CITY OF HASTINGS

ADDENDUM NO. 2

East Gate Plaza Water Meter House

Contract No. HU 2026-28

WATER METER HOUSE PLAN	
WATER METER HOUSE EAST GATE PLAZA	
HASTINGS, NE	2026

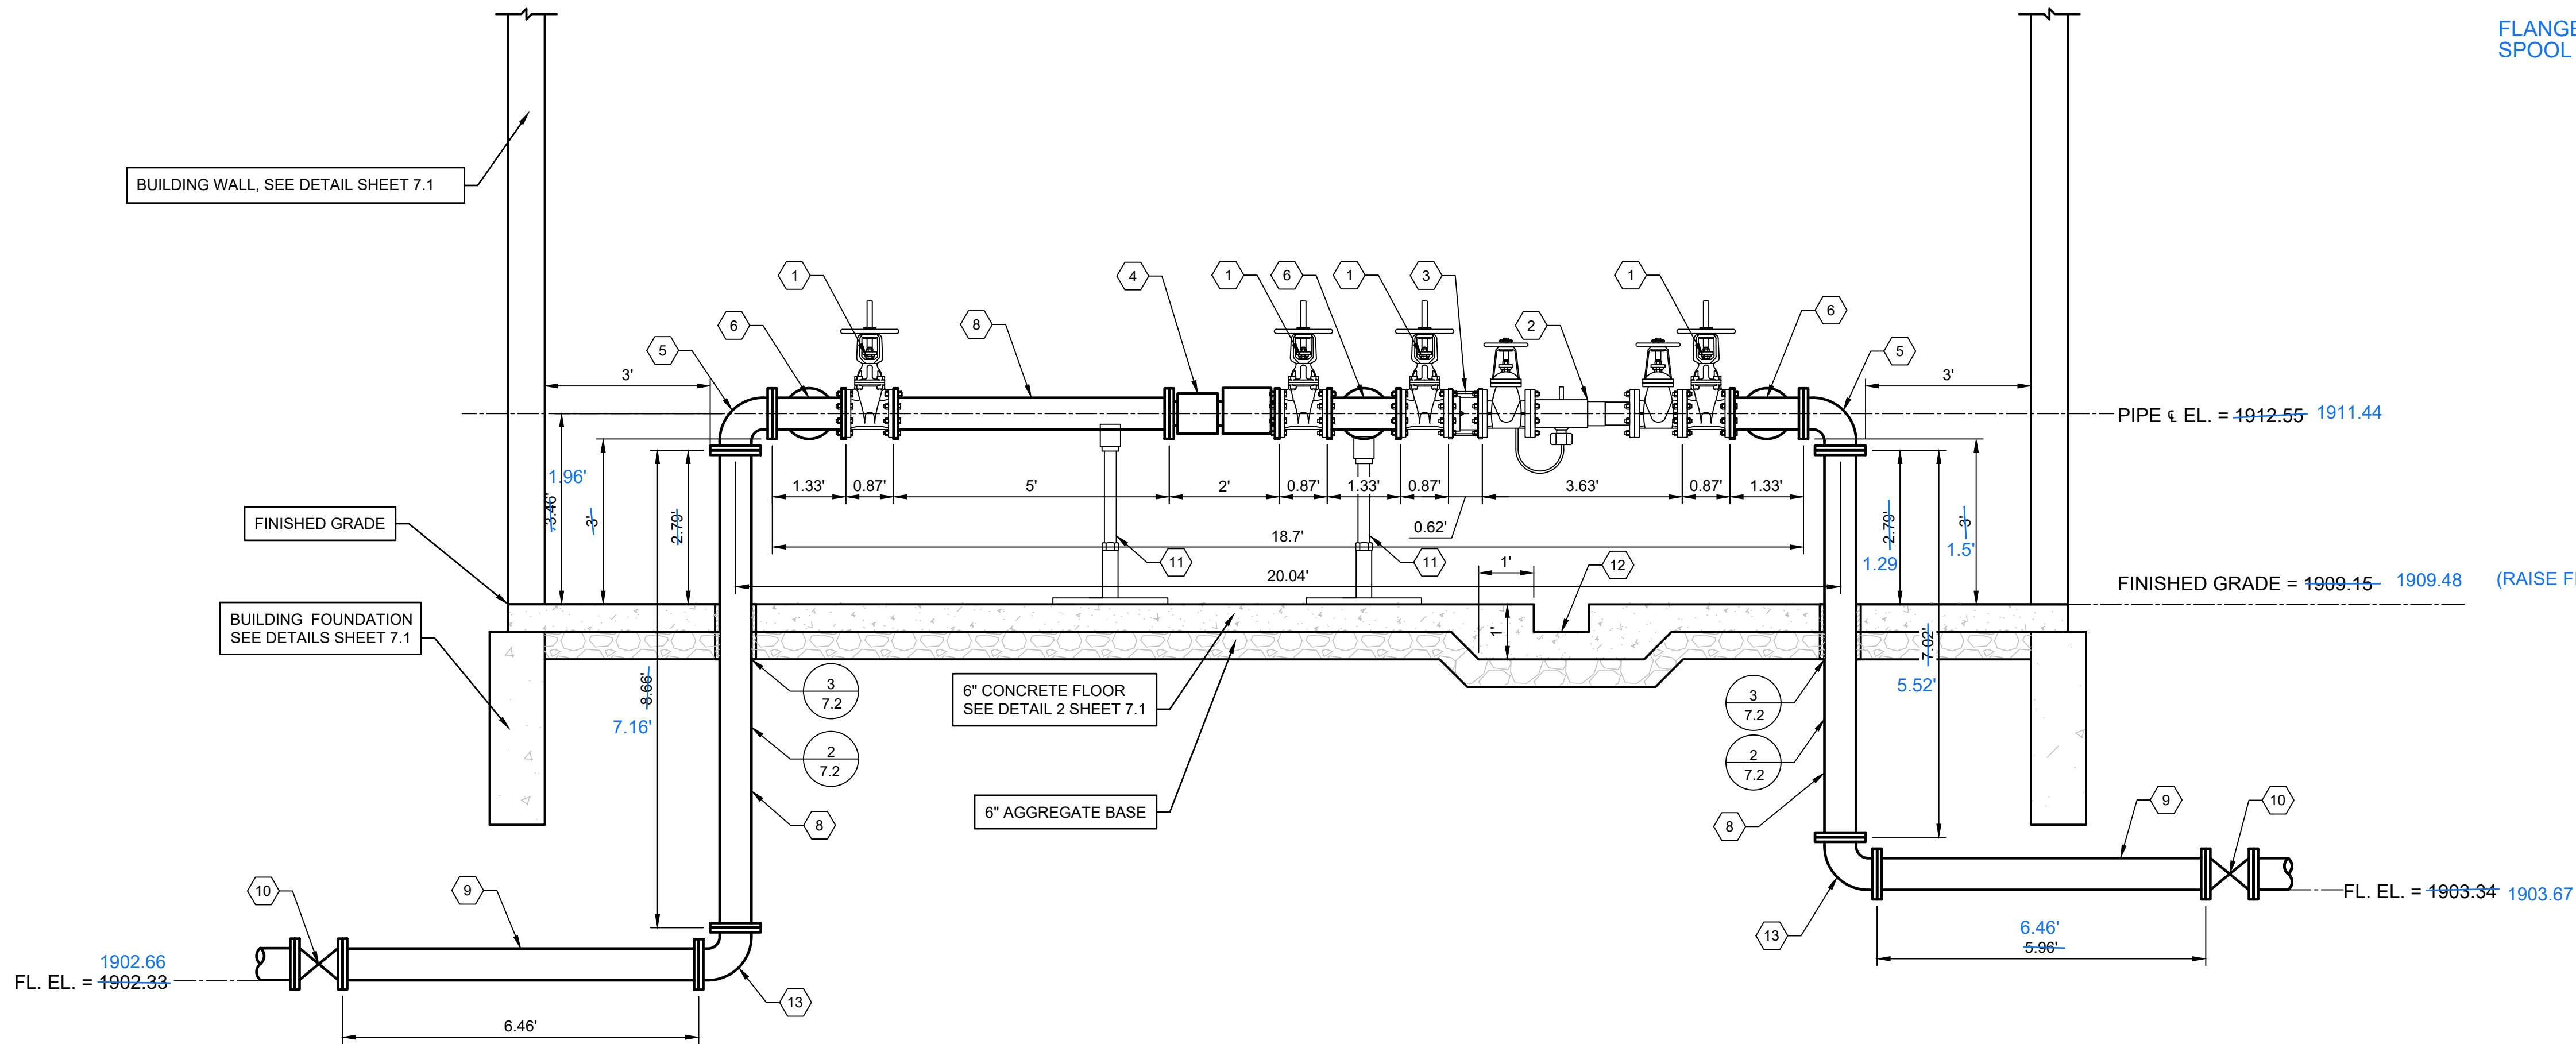
REV1: 3-13-26 Addendum 2 by Keith Miller in BLUE. Edits: Buried Piping, Above Ground Piping, Finished Floor EL.

WATER METER HOUSE SECTIONS

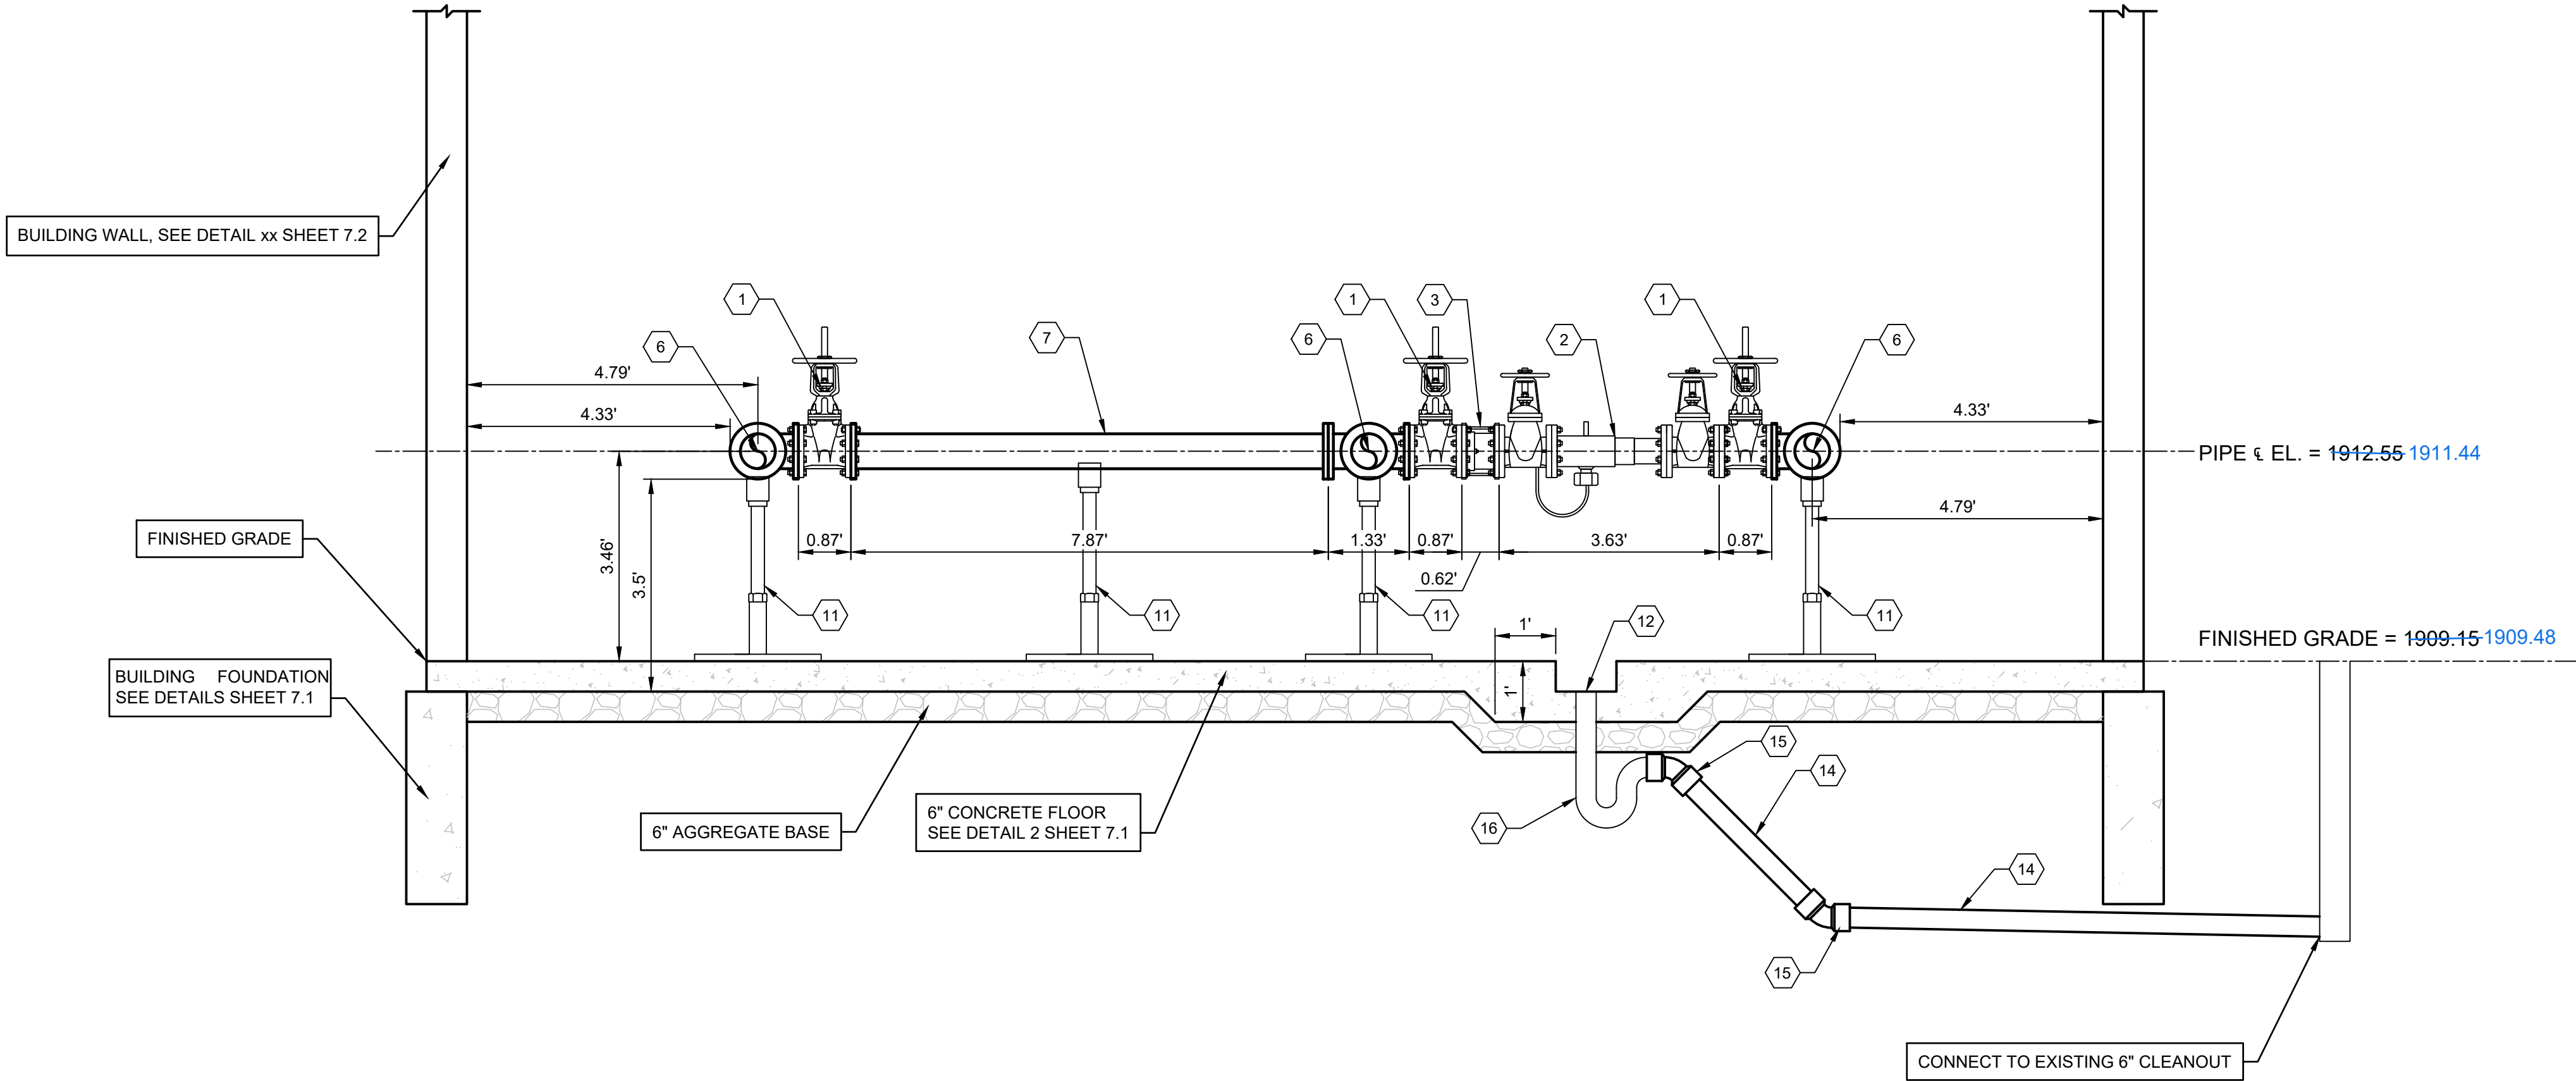
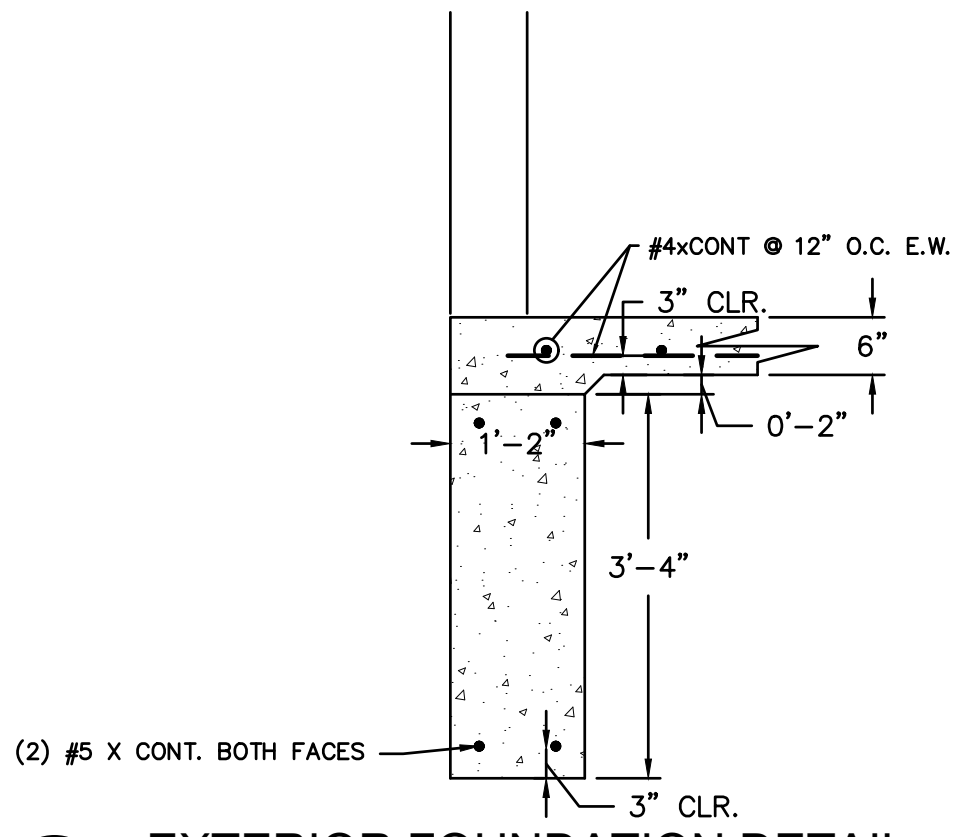
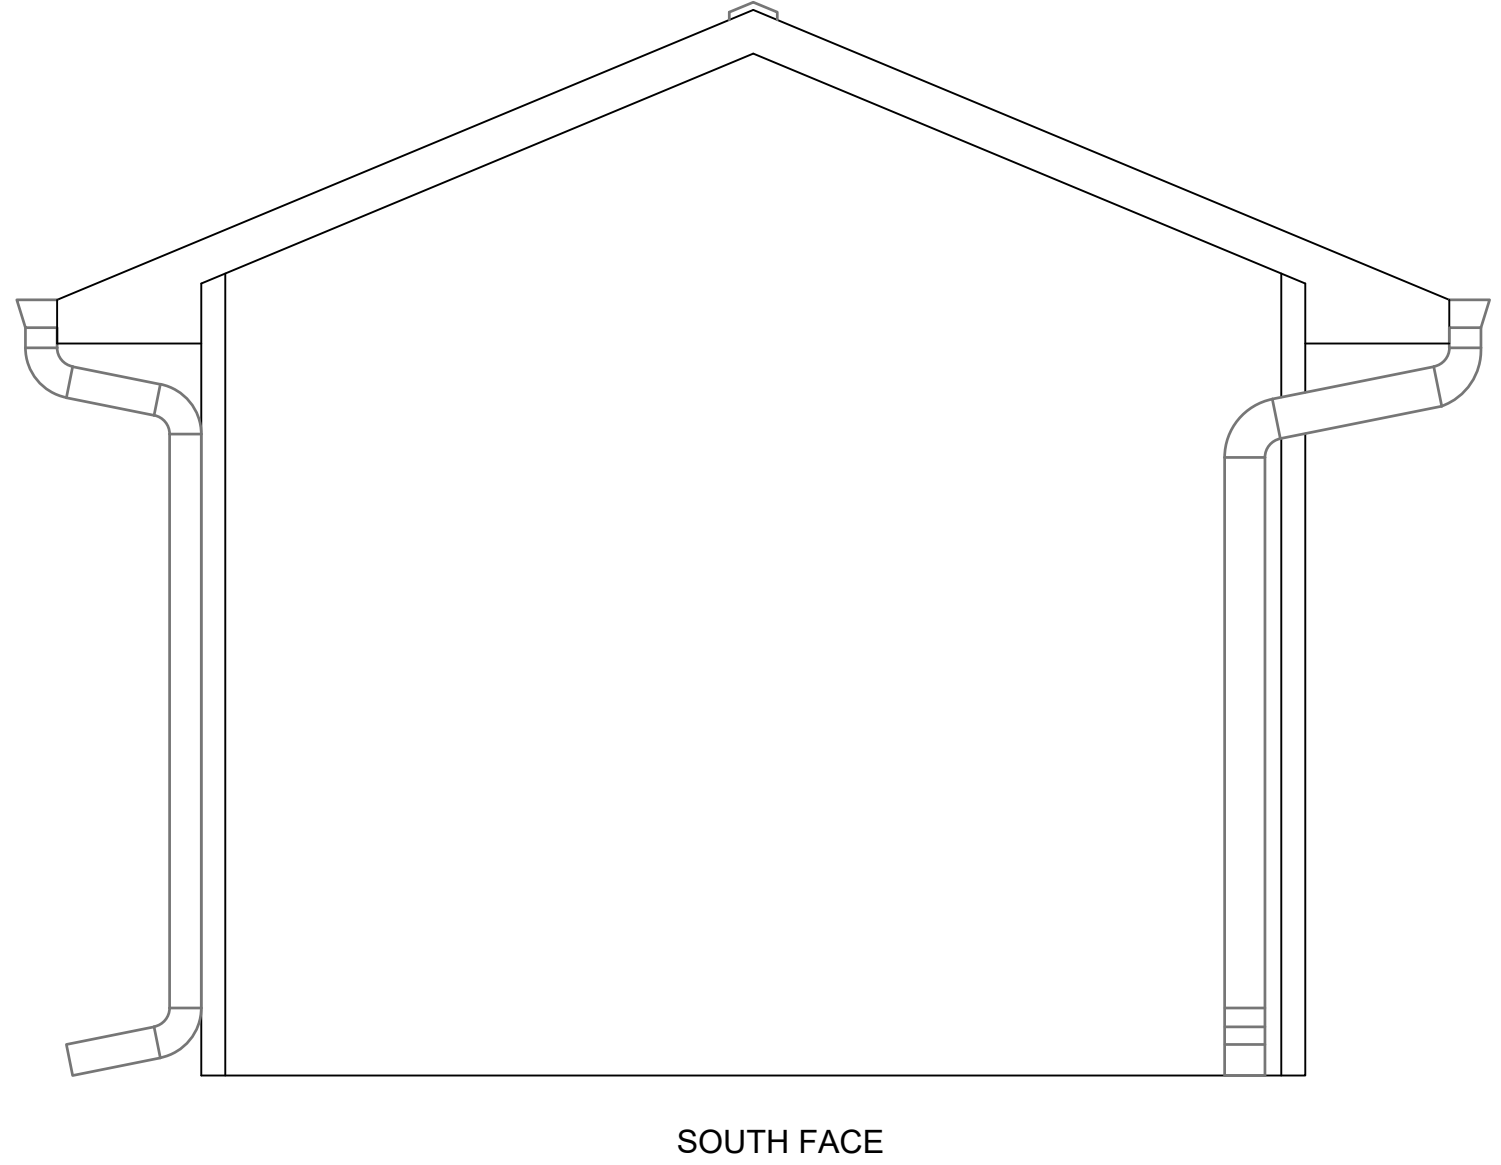
REV1: 3-13-26 Addendum 2 by Keith Miller in BLUE. Edits: Buried Piping, Above Ground Piping, Finished Floor El.
